Work Order ID 85057

Item Name: Crosstube Fwd

DRAWING NO. D212-664-141	TITLE XTUBE ASSY (205/212/412 HI FWD)	REV. D	DART AEROSPACE LTD ENGINEERING ORDER		D.E.O. NO. D212-664-141-D-1	SHEET NO. SHEET 1 OF 2	SCALE NTS
DRAWN	CHECKED	MFG. APPR.	APPROVED	DE APPR.			
DATE 11.04.07	DATE 11.04.11	DATE 11.04.12	DATE 11/04/12	DATE 11.04.12

DRAWING NO. D212-664-141	TITLE CROSSTUBE ASS'Y (205 HI FWD)	REV. D	DART AEROSPACE LTD ENGINEERING ORDER		D.E.O. NO. D212-664-141-D-2	SHEET NO. SHEET 1 OF 1	SCALE NTS
DRAWN <i>UP</i>	CHECKED <i>ASS</i>	MFG. APPR. <i>AS</i>	APPROVED <i>MD</i>		DE APPR. <i>HH</i>		
DATE 11.07.15	DATE 11.07.20	DATE 11.07.21	DATE 11/07/21		DATE 11.07.21

**D212-664-141/-141B
ASSEMBLY DETAIL**

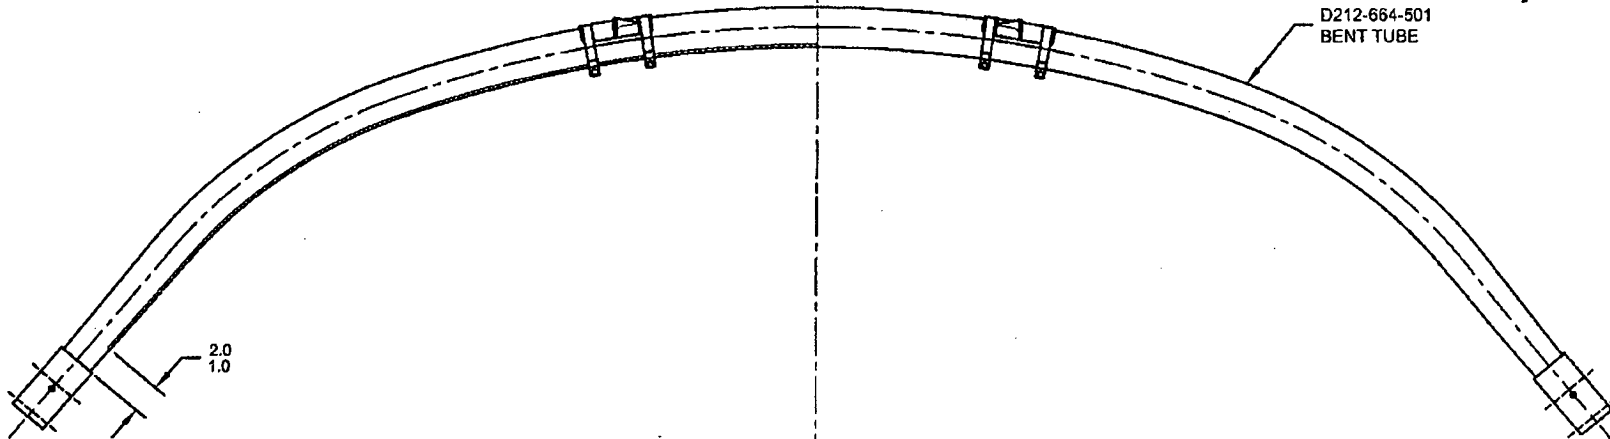
PURPOSE:

ADD AN INSPECTION WINDOW TO UNDERSIDE OF CROSSTUBE.

NOTES 2 OF SHEET 1 IS AMENDED AS FOLLOWS:

- 2) FINISH: CHEMICAL CONVERSION COAT PER DART QSI 005 4.1
PRIME INSIDE AND OUTSIDE PER DART QSI 005 4.2
MASK UNDERSIDE OF CROSSTUBE AS SHOWN (HATCHED AREA) AND
PAINT OUTSIDE PER DART QSI 005 4.2
REMOVE MASKING AND APPLY CLEAR COAT

- 2) FINISH: CHEMICAL CONVERSION COAT PER DART QSI 005 4.1
PRIME INSIDE AND OUTSIDE PER DART QSI 005 4.2
PAINT OUTSIDE PER DART QSI 005 4.2

MASK AREA PRIOR TO PAINTING,
REMOVE MASKING AFTER PAINT
AND APPLY CLEAR COAT
